SBK-L-15132

Seabrook Station

Response to Request for Additional Information for License Amendment Request 14-04
Revised Reactor Coolant System Pressure - Temperature Limits Applicable for 55 Effective
Full Power Years

Response to Request for Additional Information for License Amendment Request 14-04
Revised Reactor Coolant System Pressure - Temperature Limits Applicable for 55 Effective
Full Power Years

FIGURE 3.4-2
REACTOR COOLANT SYSTEM HEATUP LIMITATIONS – APPLICABLE UP TO 55 EFPY

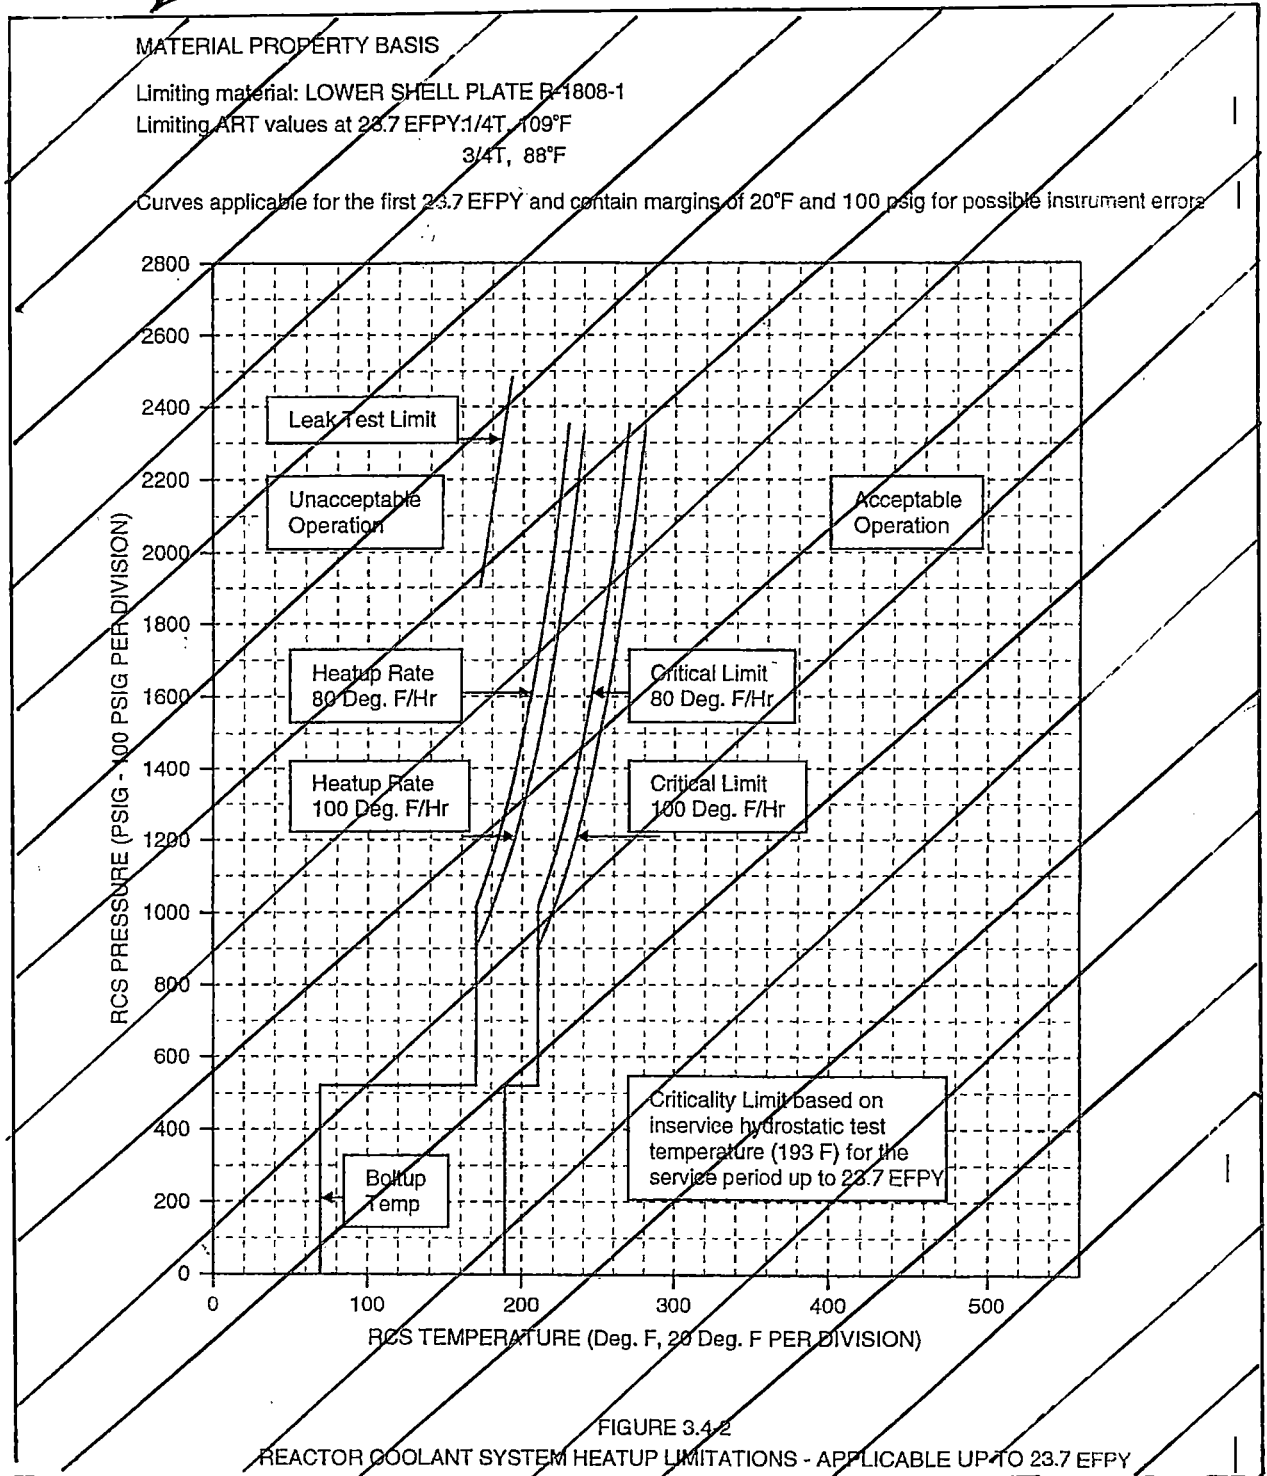
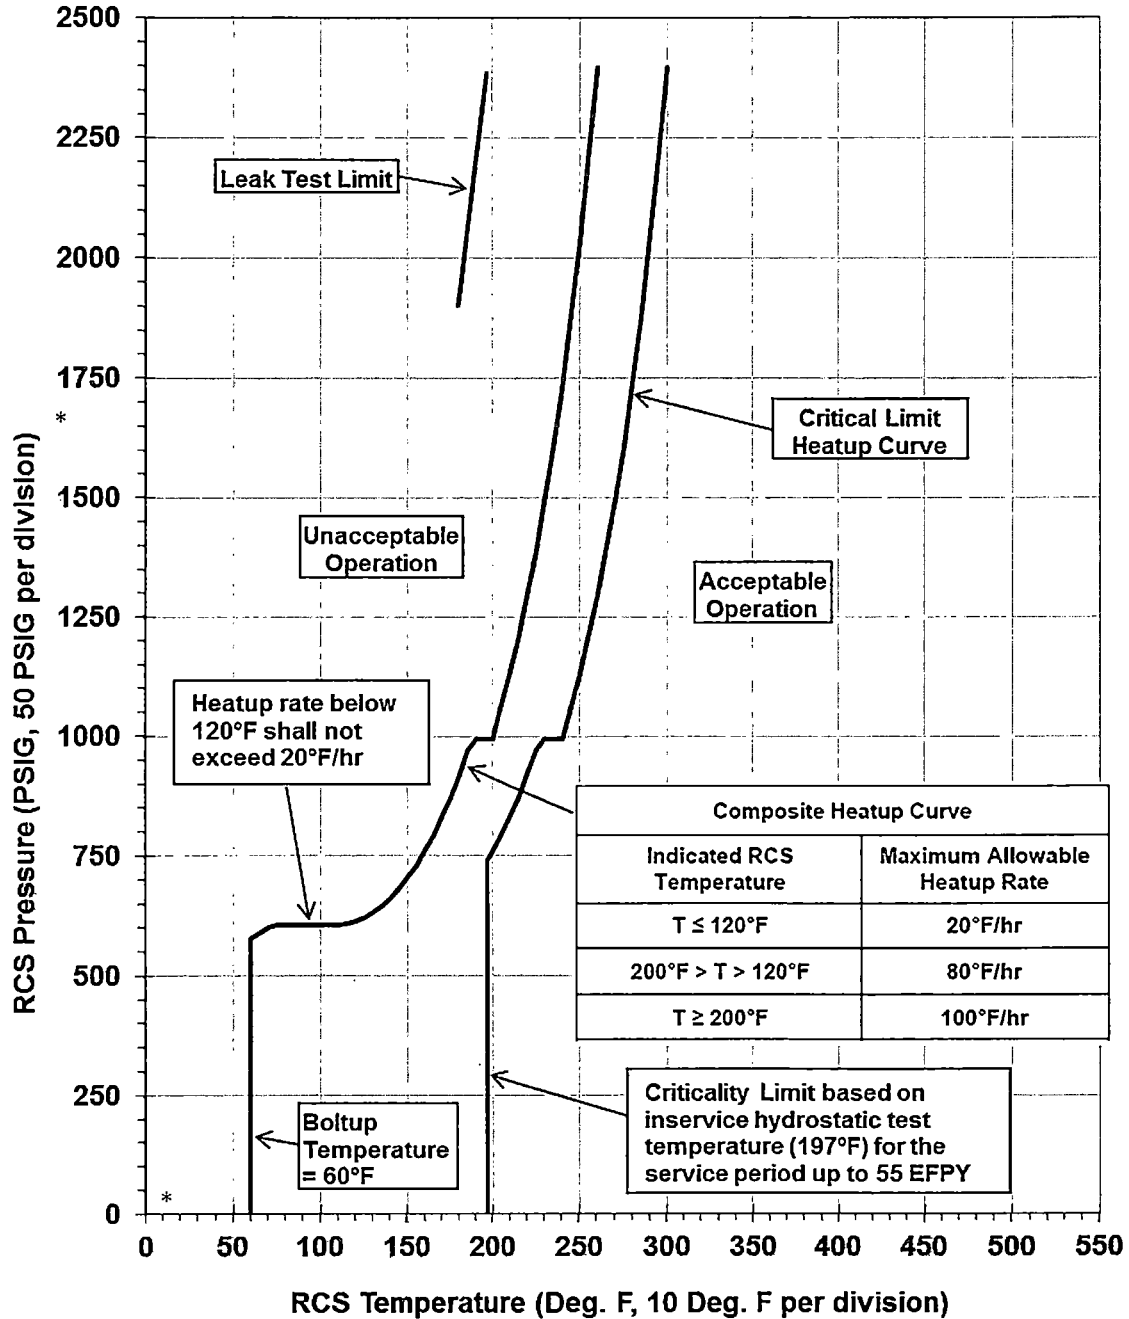
Specifically, the revised curves shift the heat up and cool down P-T Limits curve data points developed in WCAP-17441-NP by 100 psi downward and 20°F to the right to account for the instrument uncertainty. An additional 15 psi uncertainty was applied to the heat up curve above the COMS enable temperature where operationally the wide range pressure indication on the main control board could be the only available indication in some unlikely but possible scenarios.

For the heat up limitation curve, proposed TS Figure 3.4-2, a heat up rate restriction of 20°F/hr was added at temperatures at or below 120°F, corresponding to the transient defined in WCAP-17444 and the previous response to RAI 2.1.4. At temperatures greater than 120°F to less than 200°F the heat up rate of 80°F/hr maximum is specified and at greater than or equal to 200°F the maximum rate is 100°F/hr. Instrument uncertainties of 20°F and 100 psi were added to the data points in WCAP-17441-NP Table 6-3. An additional pressure uncertainty of 15 psi was added to the heat up curve starting at 200°F prior to the cold overpressure mitigation system being disabled. Considering the 20°F/hr rate restriction, pressure and temperature data from 60°F to 80°F (40°F to 60°F without the instrument uncertainty of 20°F) were determined using the more limiting pressure rate change between the existing 80°F/hr heat up data and the steady state data. Linear extrapolation of the 60°F to 65°F allowable pressure change of 13 psi per 5°F was applied to the heat up curve pressure limits from 60°F to 80°F. These heat up rate limitations and instrument uncertainties additions result in all pressure limitations at or below 225°F, in the COMS enable temperature region, being above and protected by the COMS system set point curve in TS Figure 3.4-4.

DELETE

Curves applicable for the first 55 EFPY and contain margins for possible instrument errors

* Curve is Applicable for RCS Vacuum fill

FIGURE 3.4-3
REACTOR COOLANT SYSTEM COOLDOWN LIMITATIONS – APPLICABLE UP TO 55 EFPY

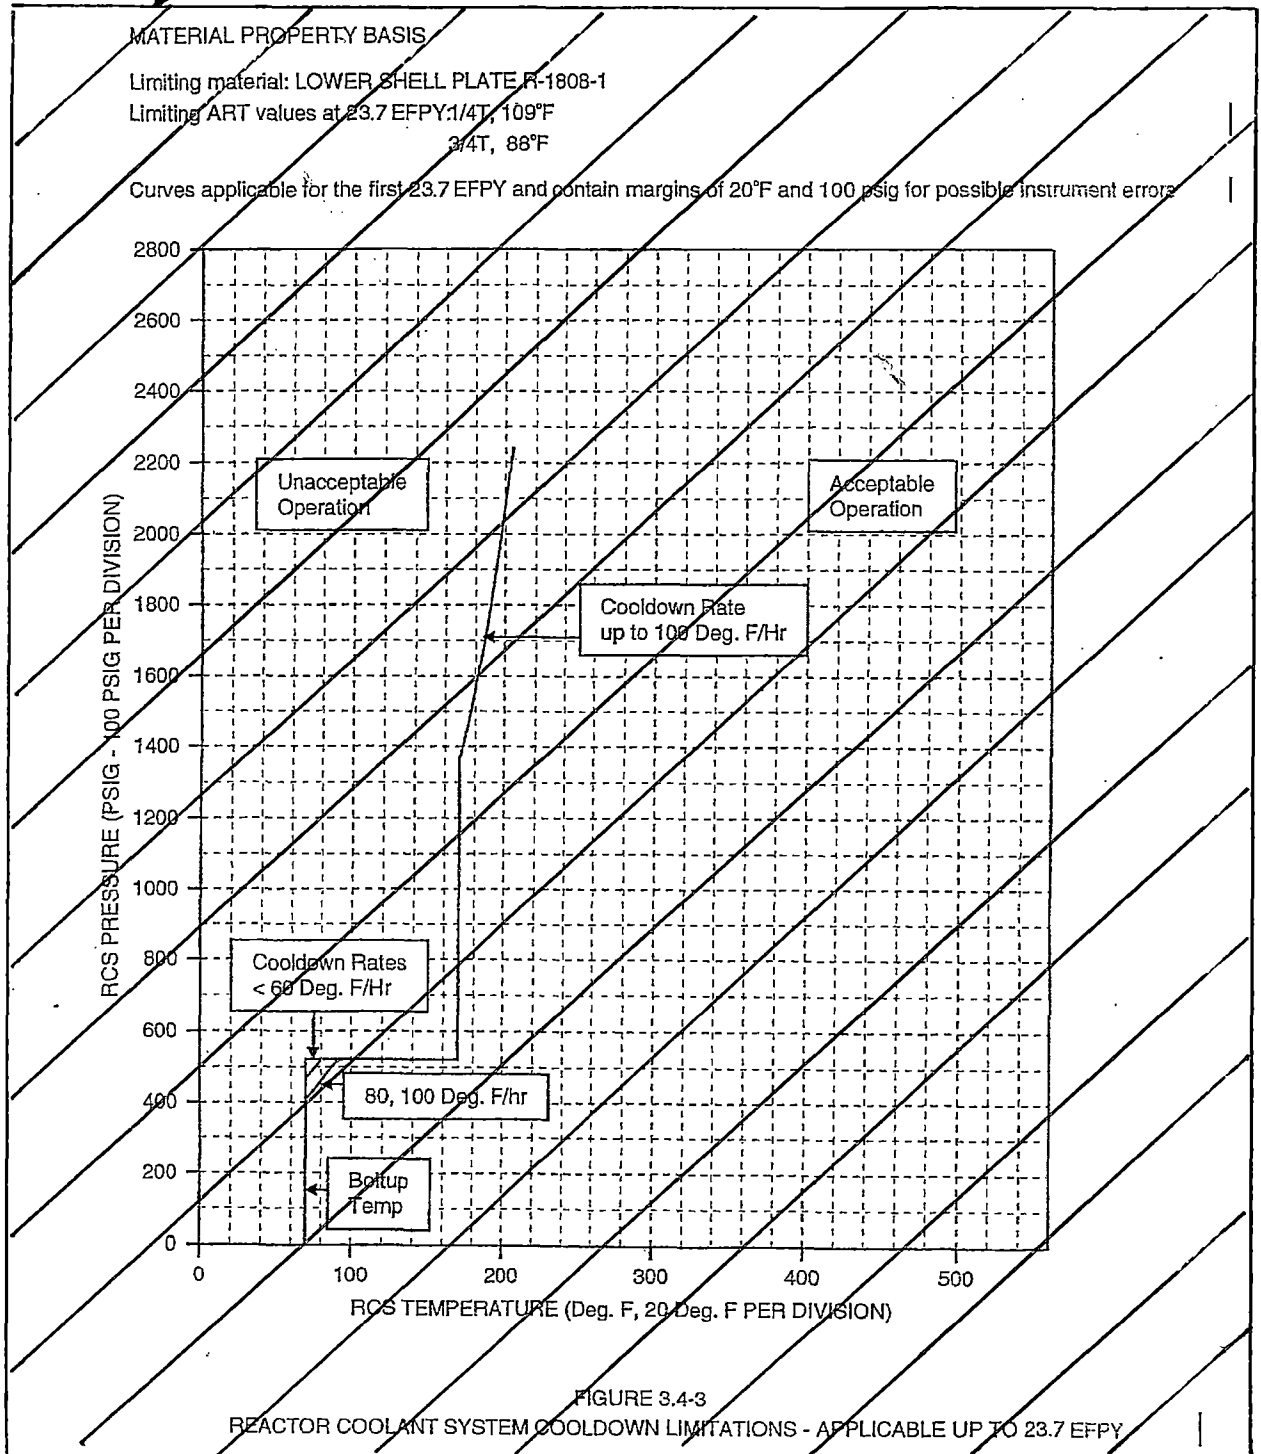
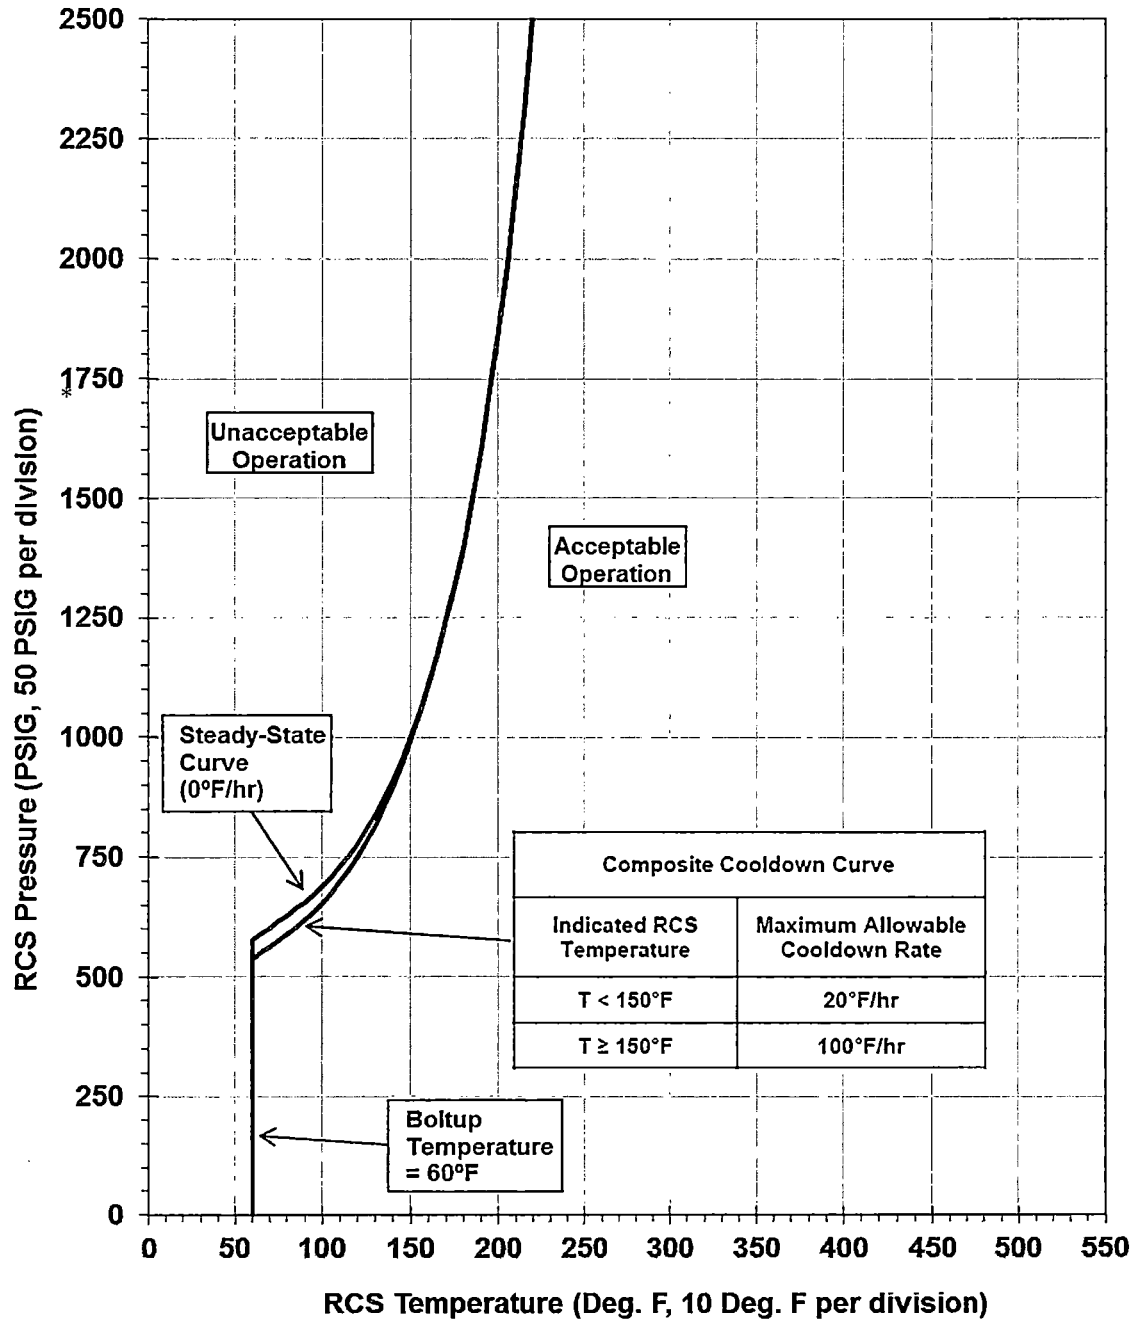
For the cool down limitation curve, proposed TS Figure 3.4-3, the cool down rate is restricted to 20°F/hr at temperatures less than 150°F. Instrument uncertainties of 20°F and 100 psi were added to the data points in WCAP-17441-NP Table 6-4. Since the entire curve is to the left and above the COMS enable temperature and pressure limits identified in TS Figure 3.4-4, the additional 15 psi uncertainty was not

necessary. Pressure and temperature data from 60°F to 80°F (40°F to 60°F without the instrument uncertainty of 20°F) were determined by linear extrapolation of the pressure rate change between 60°F to 65°F for the 20°F/hr cool down data and the steady state data which results in a 13 psi change per 5°F. These cool down rate limitations and instrument uncertainties additions result in all pressure limitations being above and protected by the COMS system set point curve in TS Figure 3.4-4.

DELETE

Curves applicable for the first 55 EFPY and contain margins for possible instrument errors

* Curve is Applicable for RCS Vacuum fill
